Paper for Consideration by ENC WG

Issues with the ECDIS Chart 1 Data

Submitted by:	SevenCs GmbH (Holger Bothien)
Executive Summary:	Reports some Issues with the ECDIS Chart 1 datasets
Related Documents:	S-52 Preslib Ed 4.0.3 Part 1 + Digital data
Related Projects:

Unnecessary M_COVR object in the dataset AA5C1CDE.000

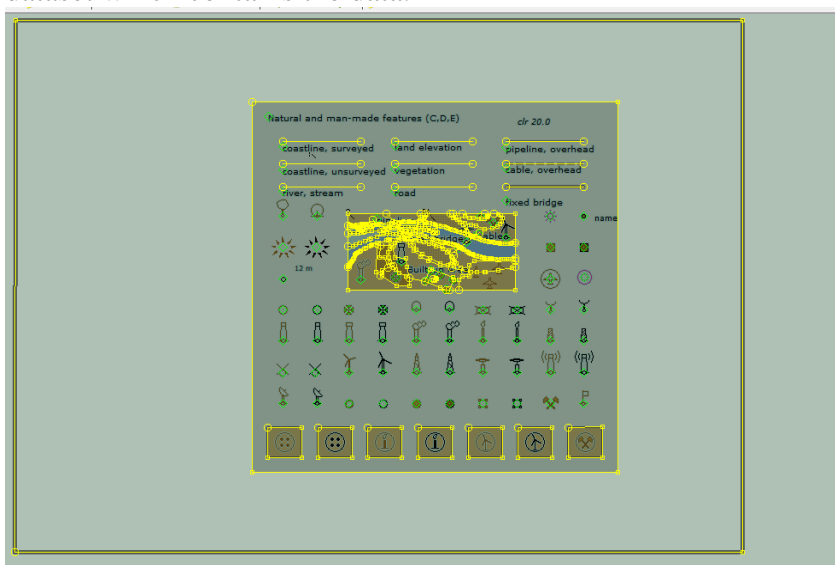
There are two M_COVR features FE0000000001 and FE0000000136 which overlap.

The first object seems to be unnecessary since the second one correctly defines the area of the dataset which contains the data.

Note: The picture above is made from SevenCs Designer in a mode combining ECDIS mode and spatial data view.

- Delete the unnecessary M_COVR feature (and its geometry)
- Make the PRDARE objects smaller
- Adding the settings to the presentation library document (Chapter 16)
- The plot 4 should be amended to reflect the smaller PRDARE objects
